Private Fuel Storage, LLC

**RESPONSES TO SECOND ROUND EIS
REQUEST FOR ADDITIONAL INFORMATION
DOCKET NO. 72-22/TAC NO. L22462
PRIVATE FUEL STORAGE FACILITY
PRIVATE FUEL STORAGE L.L.C.**

References: 1) NRC Letter, Flanders to Parkyn, Request for Additional Information for the Environmental Impact Statement, dated August 19, 1999

Figure 2
PFS Rail Line at Low from I-80

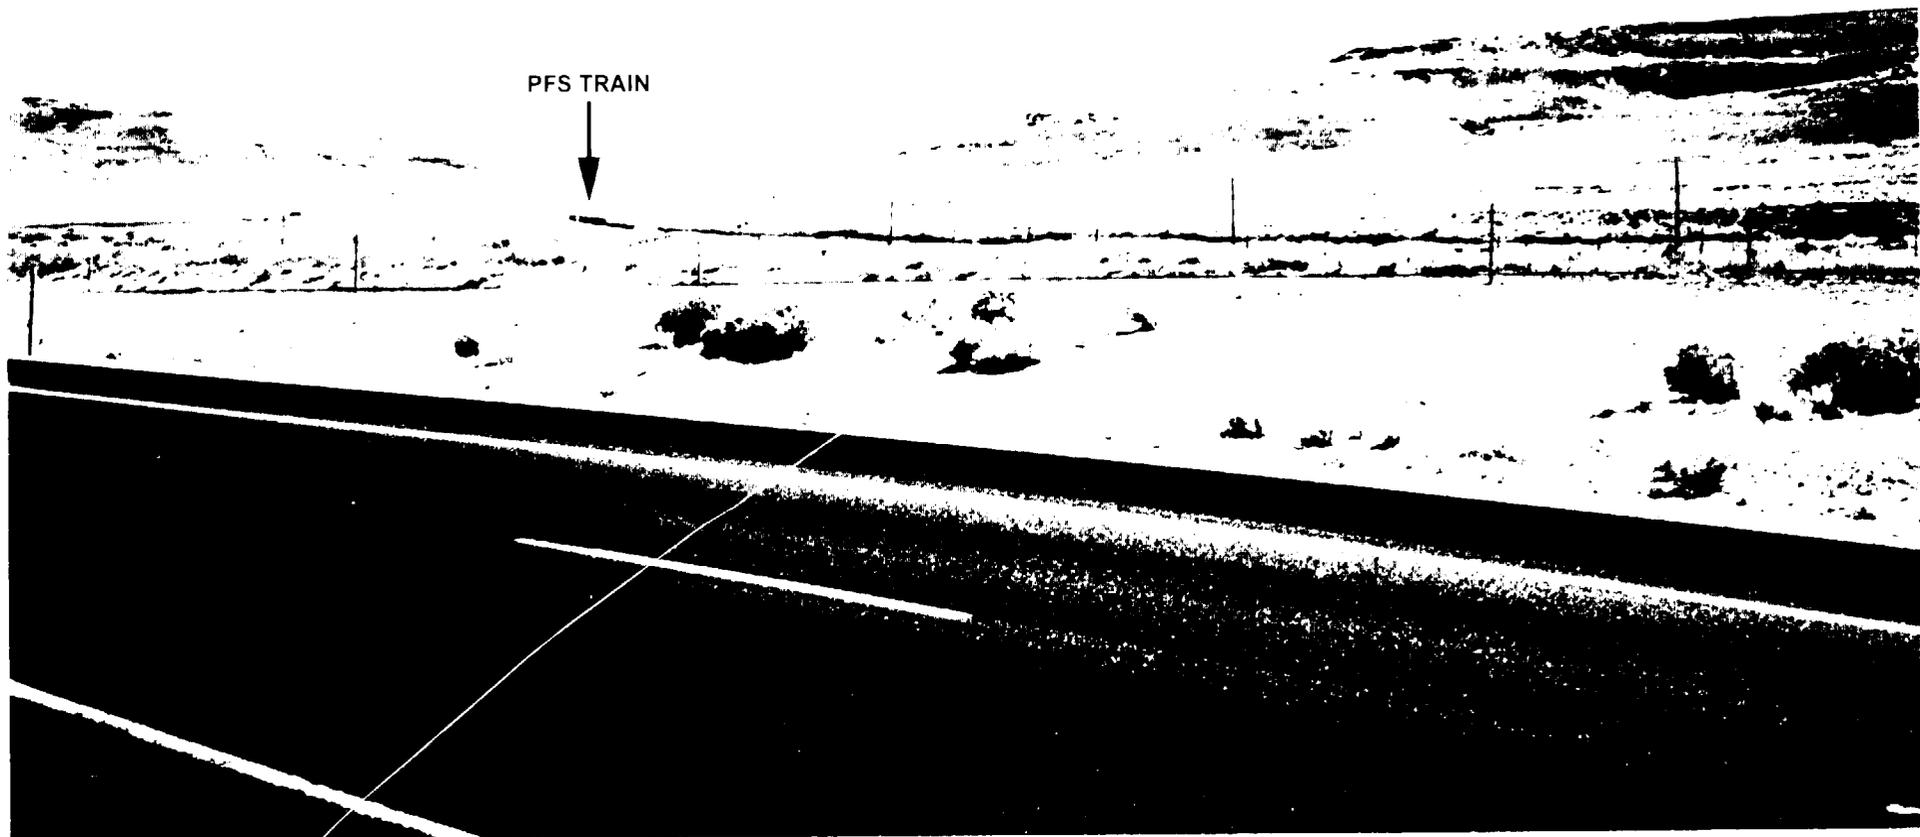
Include an estimate of the number of casks held, the location (i.e., inside the ITF or on rail siding next to the ITF etc.), and the duration of the holding periods. Include a description of the visibility of the casks being held at the ITF or the Skunk Ridge rail siding to individuals traveling on I-80 or other nearby roads.

The February 18, 1999, RAI response indicates that the average number of rail shipments per year is anticipated to be 50, and the average number of casks shipped per year is expected to be 100 to 200 a year. This implies that an average of 2 to 4 casks will be received each shipment. Since the RAI response indicates that a fleet of two heavy haul tractor/trailers will be used, it appears that PFS anticipates casks will be held at the ITF for some period of time. It is unclear whether PFS expects casks to be held at the Skunk Ridge rail siding.

Westbound I-80 vehicular traffic, traveling at the posted speed limit of 75-mph, approaching the Low siding area, would have a limited opportunity for viewing a SNF train or empty cars that are stationary at the siding area (Figure 1). Since the siding area is substantially below grade (at grade to 27' deep), the stationary SNF train or parked empty cars would be hidden from view or partially visible due to the natural topography of the siding area (Figure 2). Eastbound I-80 traffic approaching the Low area would be visually blocked from seeing the siding area until after passing the highway overpass crossing I-80 at which point the siding area would be adjacent to or behind the viewing public (Figures 3 and 4). Again, the stationary SNF train or empty cars would be hidden or only partially visible due to the topography of the area and the fact that the siding area will be substantially below grade. The view of any of the rail equipment on the sidings would be limited to the upper portion of a car or locomotive.

FIGURE 1 – Low, UT looking west. Railroad sidings will be at grade on the left to 27' below grade in the distance at the railroad mainline (center of photo).

FIGURE 2 – Low, UT looking south at the start of the westbound exit to the I-80 vehicle overpass. Rail sidings will be approximately 15' to 22' below grade left to right at this point.
